POCONO TOWNSHIP PLANNING COMMISSION

AGENDA

November 12, 2024 6:00 p.m.

**SUBJECT: TANNERSVILLE POINT APARTMENTS – PRELIM/FINAL LAND DEVELOPMENT
PLAN AND LOT CONSOLIDATION – REVIEW NO. 2
POCONO TOWNSHIP, MONROE COUNTY, PENNSYLVANIA
POCONO TOWNSHIP LDP NO. 1358, T&M PROJECT NO. POCO-R0730**

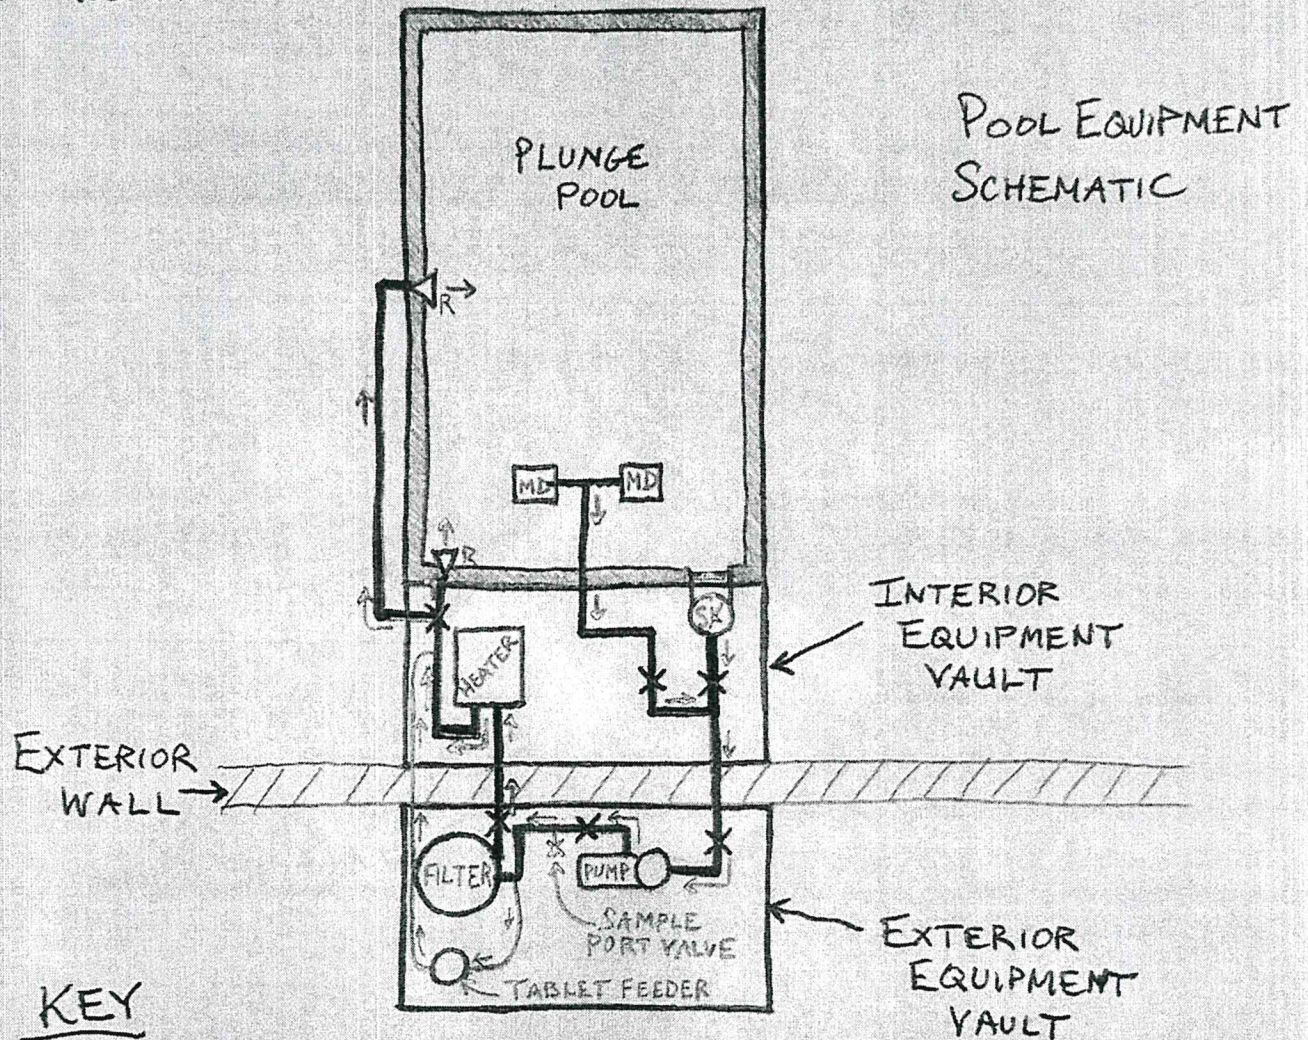
Sorry it's taken so long to get this information back to you. The following is a summary of the challenges and recommended changes. Attached is a drawing of the layout and also the state code for testing and sampling. It is in the code the protocol for the location of taking the weekly bacteria sample. You would need approval from the local municipality to have the sample taken from an alternate location and also to move the equipment.

1. Construct additional boxes/trunks/benches for each in-room pool to house a sampling port and allow the addition of an automated chemical controller system.
 - a. Move pump, cartridge filter and the bromine tablet feeder to the outer box
 - b. Add water sampling tap after pump but before filter, heater and chemical feeder. This water always in circulation represents unfiltered untreated water from the body of water.
 - c. Boxes would be protected from freezing and accessible to maintenance staff.
 - d. Pocono Township request
 1. Request to relocate filter equipment to outside of building wall into an equipment cabinet.

Equipment will be move just a few feet to the outside of the existing wall.

2. Request an exemption from the standard collection protocol. The protocol is to collect a weekly bacteriological sample from 30" deep from the center of the pool. Request to collect the sample from a sampling port in the filter cabinet. This water would be water from the unit coming from the skimmer and bottom drain line. The only concern from sampling at that location is the remote possibility that if a biofilm forms in the plumbing the sample may have a slightly higher chance of being positive for bacteria while the standard method would not show that. This could be argued as a higher standard.
